DATE: 01/29/26
TO: All Bidders
FROM: David Cienfuegos, Purchasing Specialist
SUBJECT: Addendum 1 – Bid 722 Moorpark College ANCT Zoo Visitor Bleachers & Animal Shelter Project

BID #722 – Moorpark College – ANCT ZOO VISITOR BLEACHERS AND ANIMAL SHELTER

ADDENDUM 001, dated 01/29/2026

DRAWING changes and clarifications noted as Addendum 01 and dated 01/29/2026:

DEMOLITION SITE PLAN

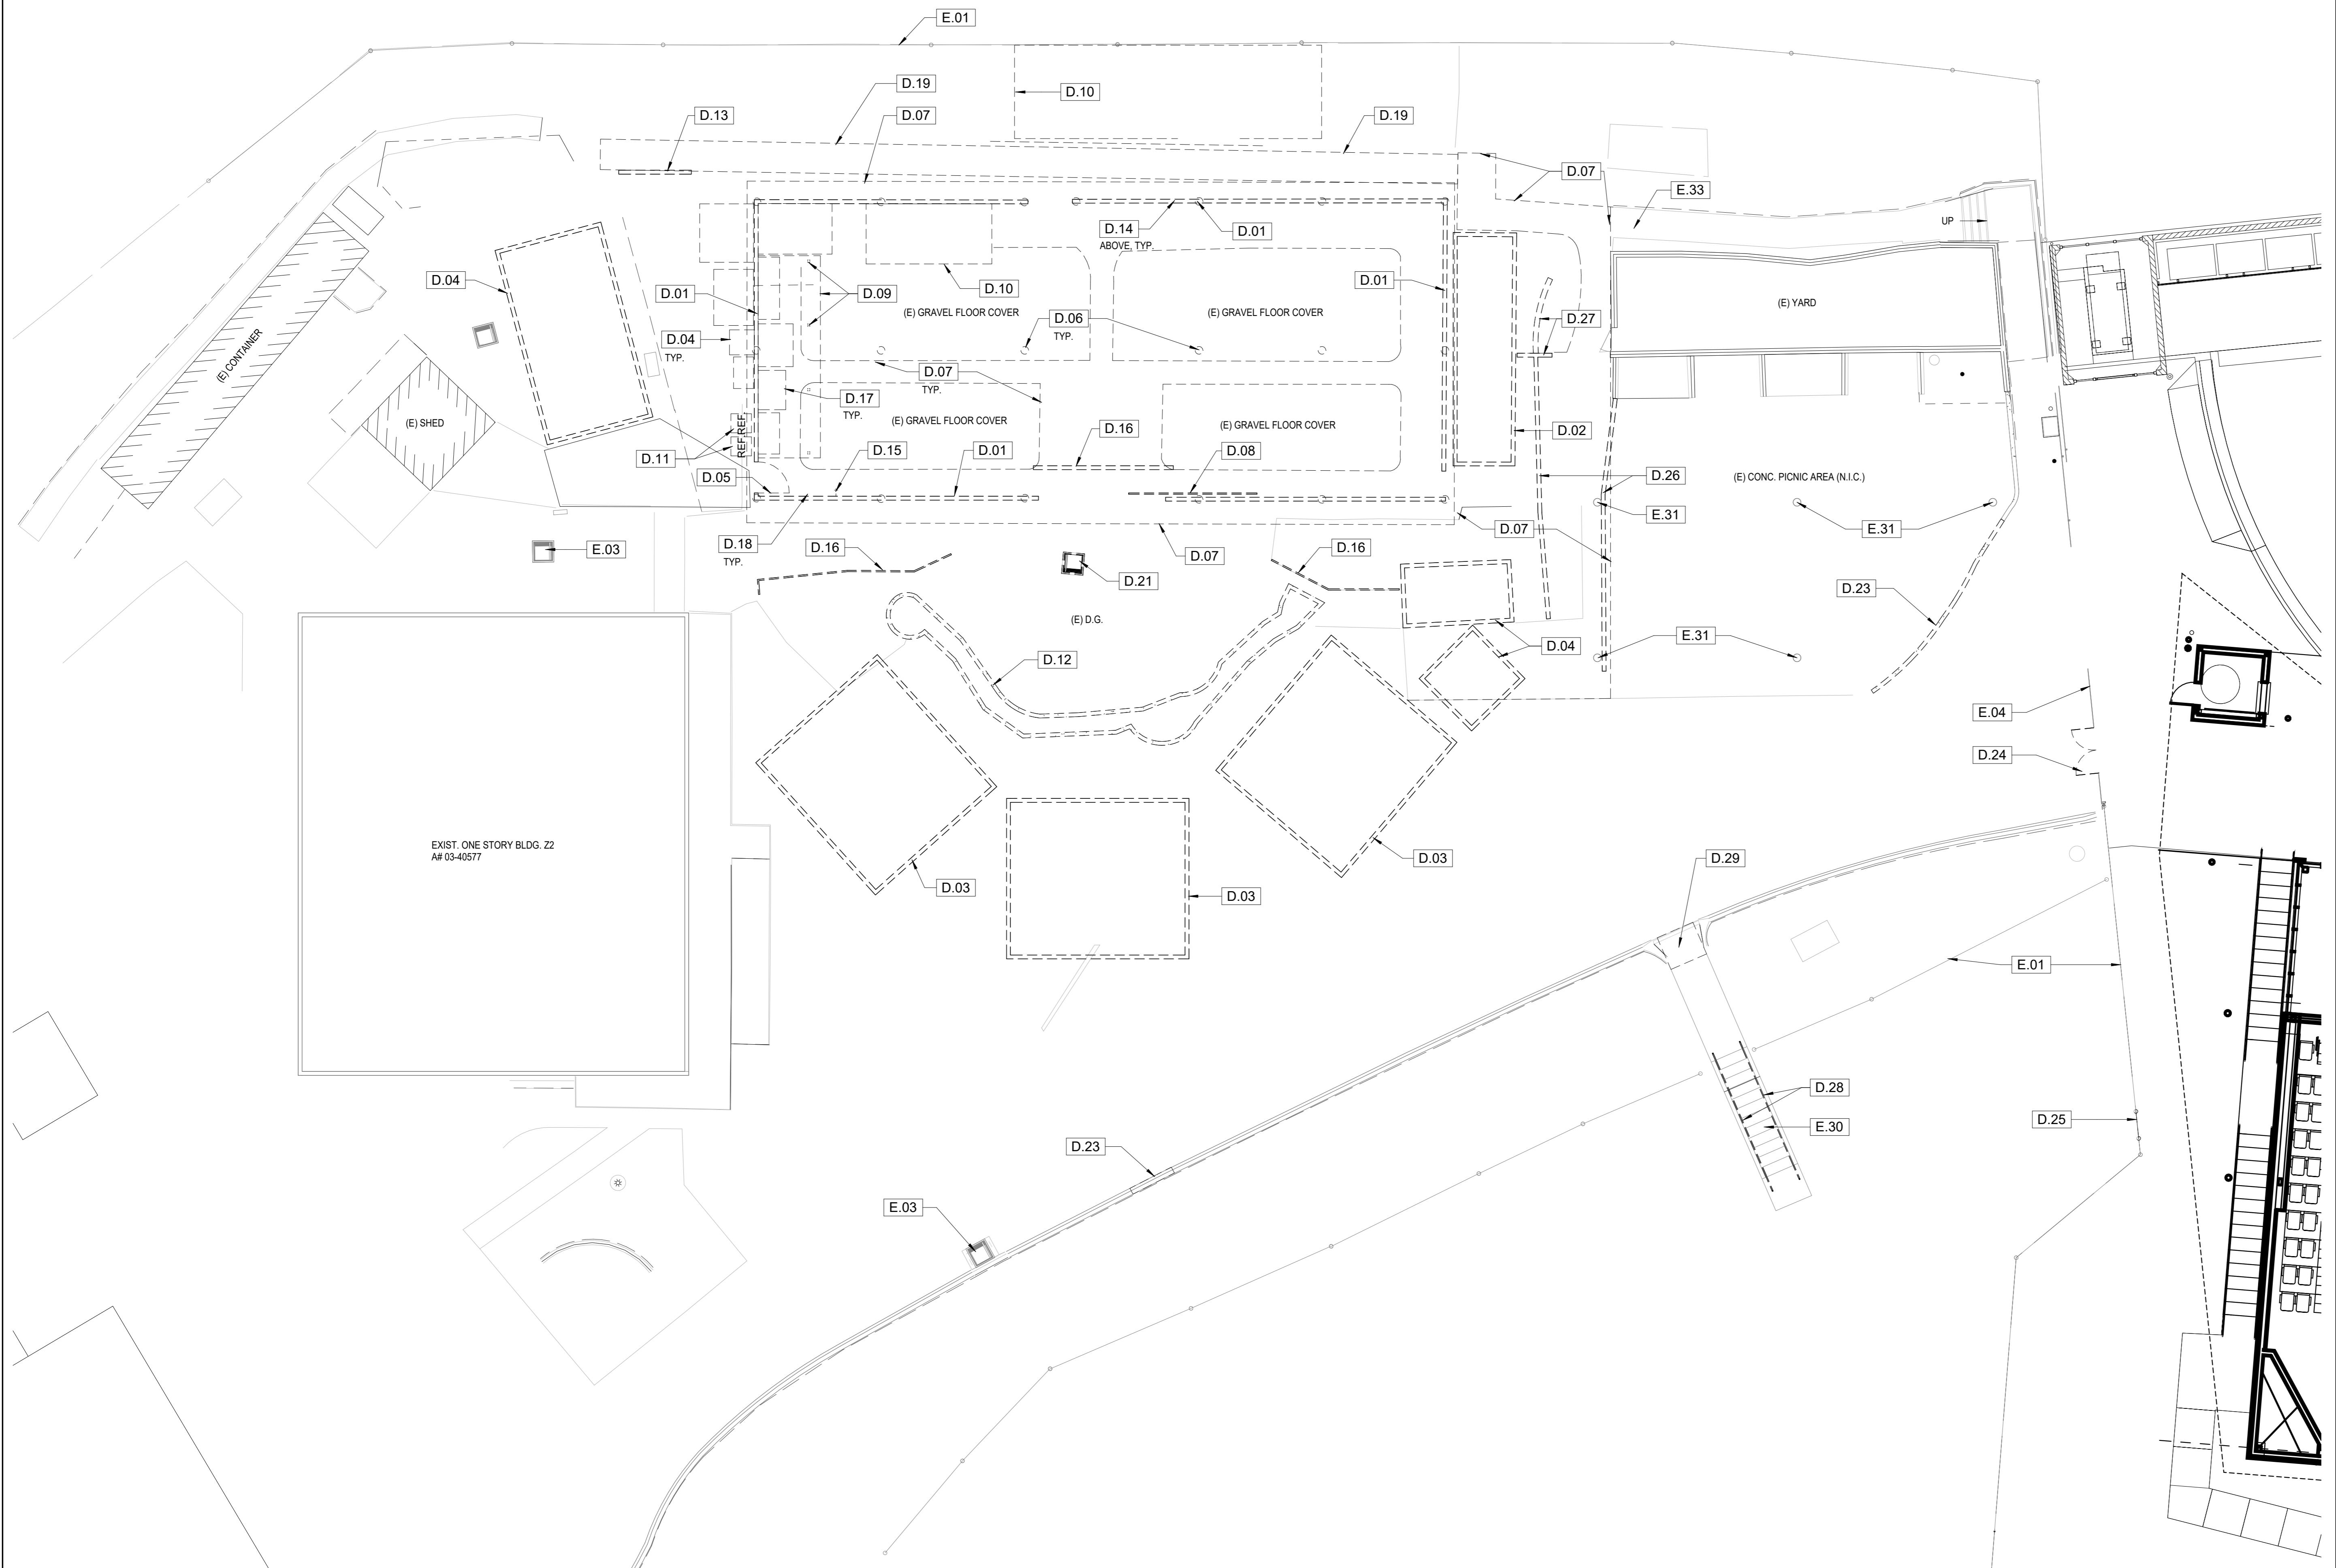
ADDENDUM 1 - PROVIDE AND MAINTAIN SCREENING FABRIC ON TEMPORARY FENCING FACING THE MAIN ACCESS ROAD. NOTE THAT THIS IS A HIGH WIND AREA.

SIGNAGE PLAN &
SCHEDULE

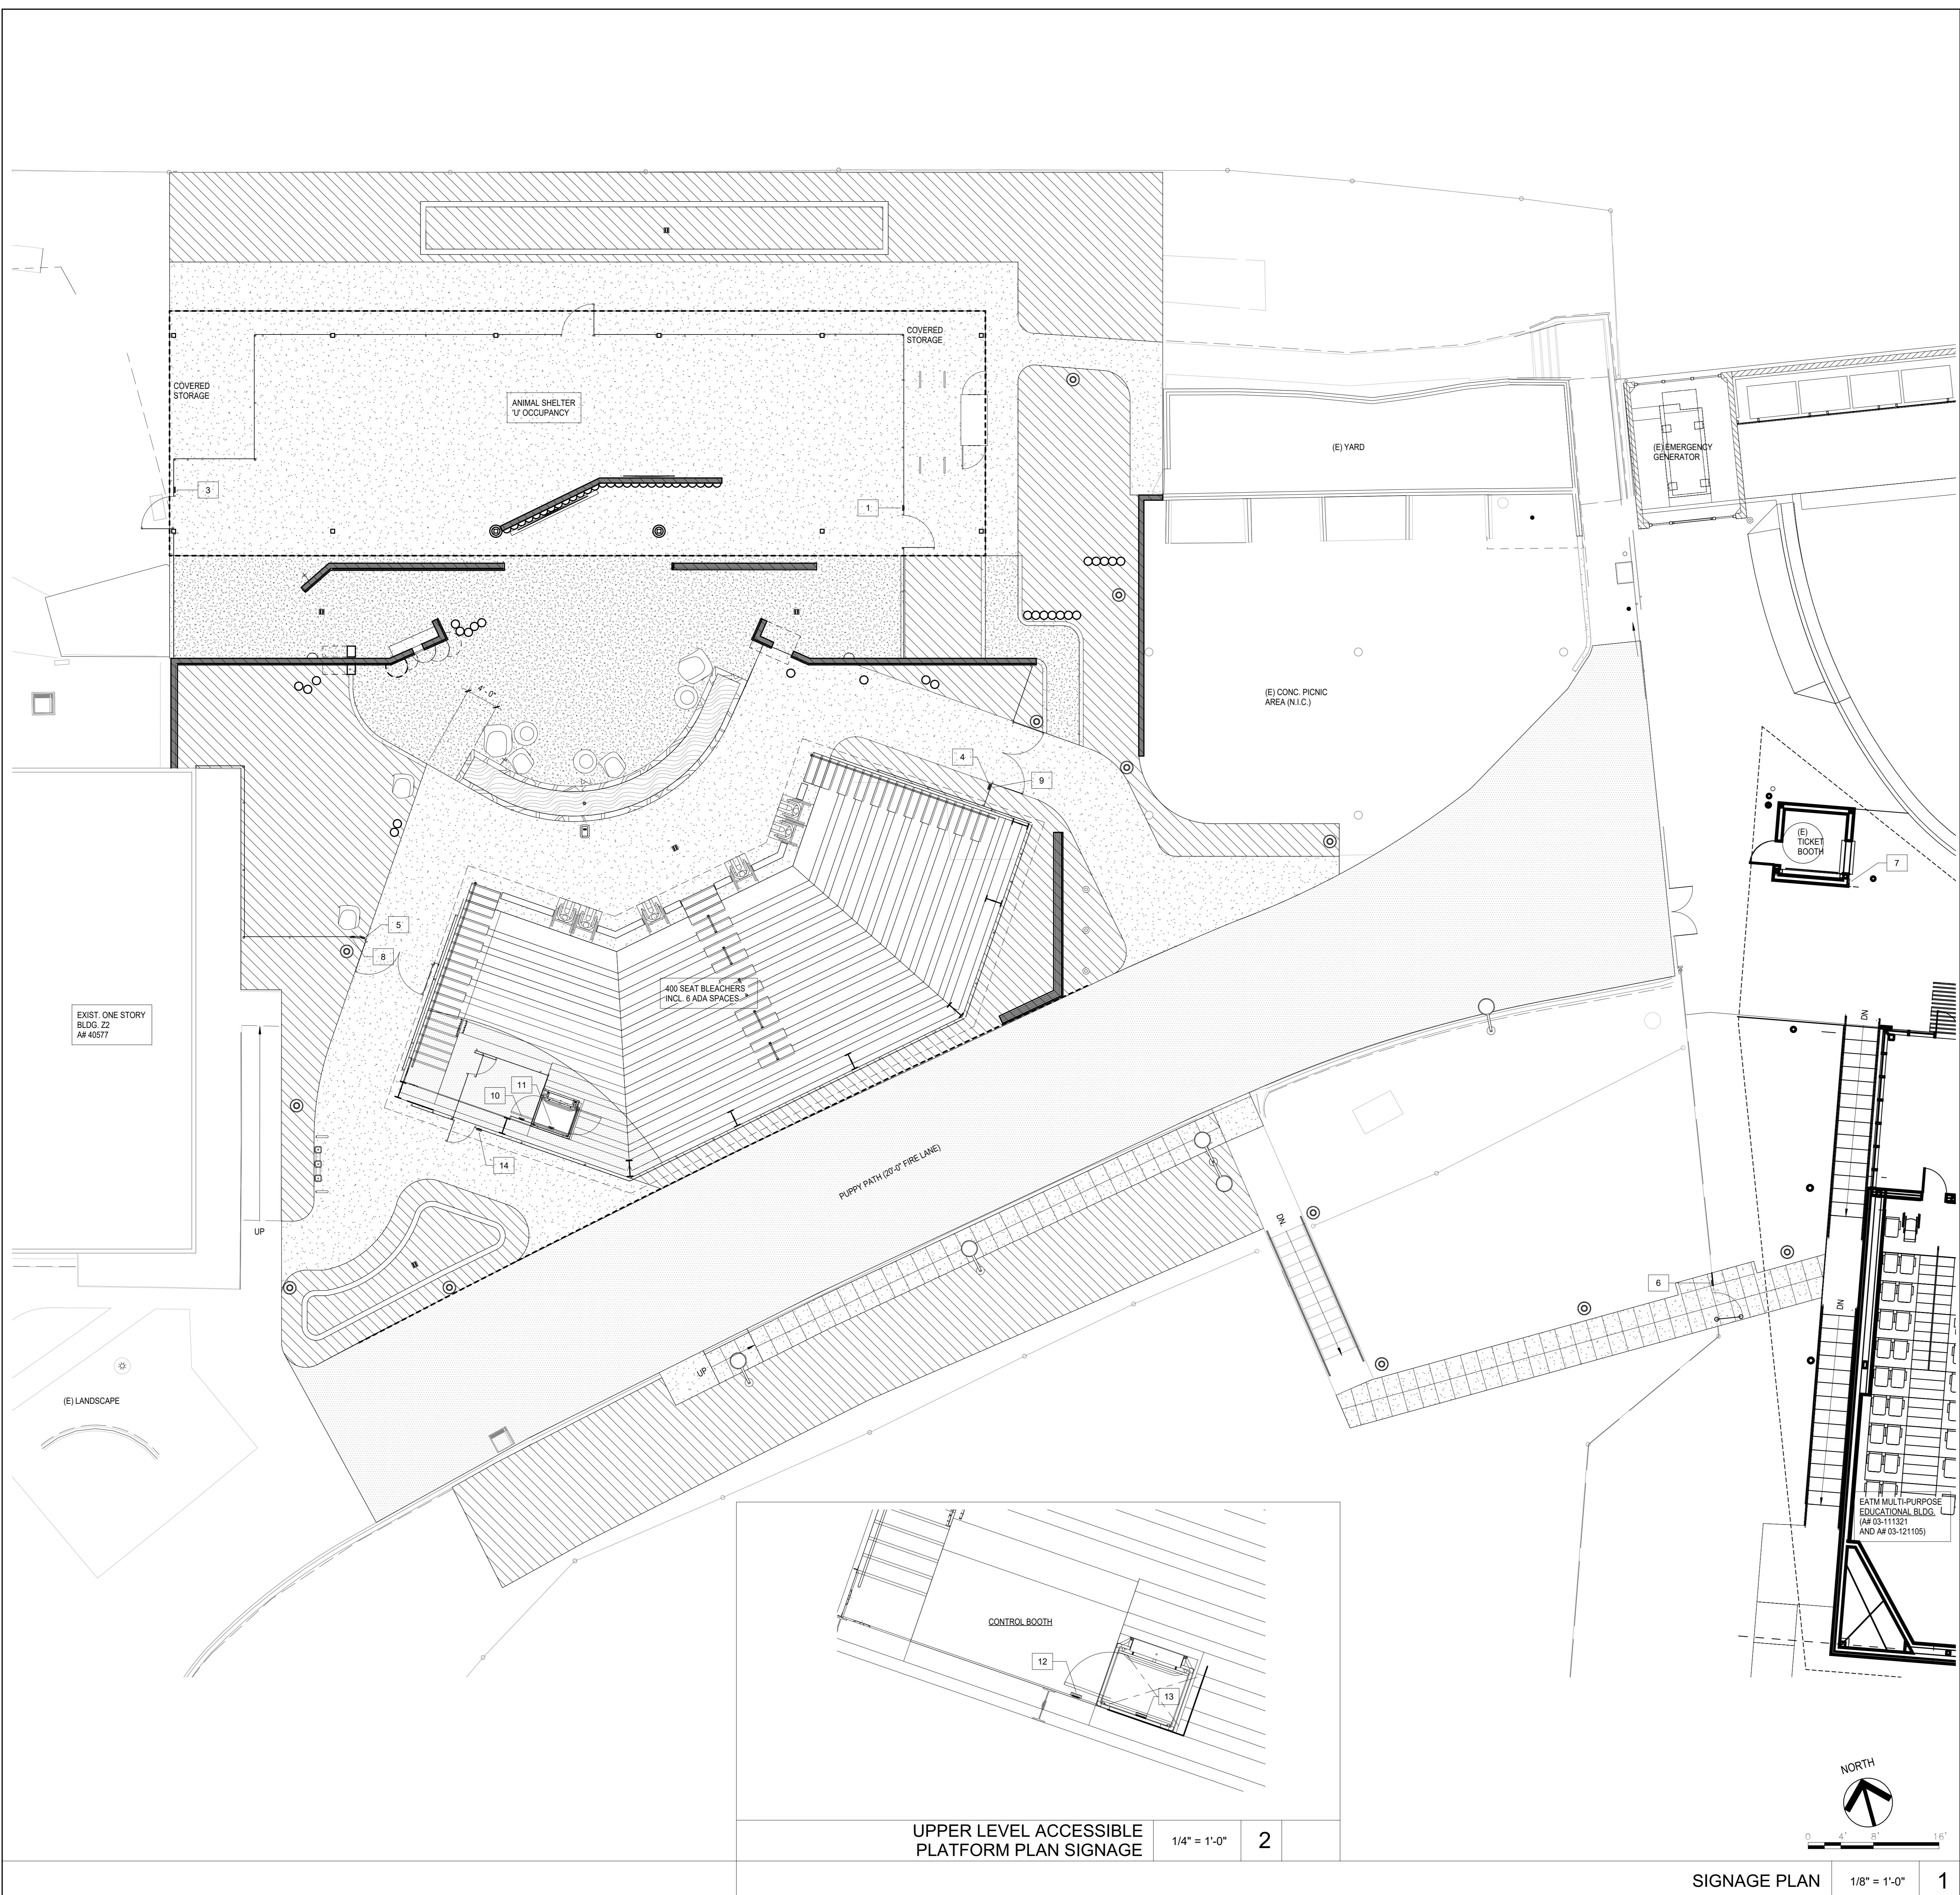
IN ADDITION TO SIGNAGE LISTED HERE, PROVIDE SITE
SIGNAGE PER ADDENDUM 1, "MOORPARK COLLEGE ZOO
SIGNAGE", 23 PAGES
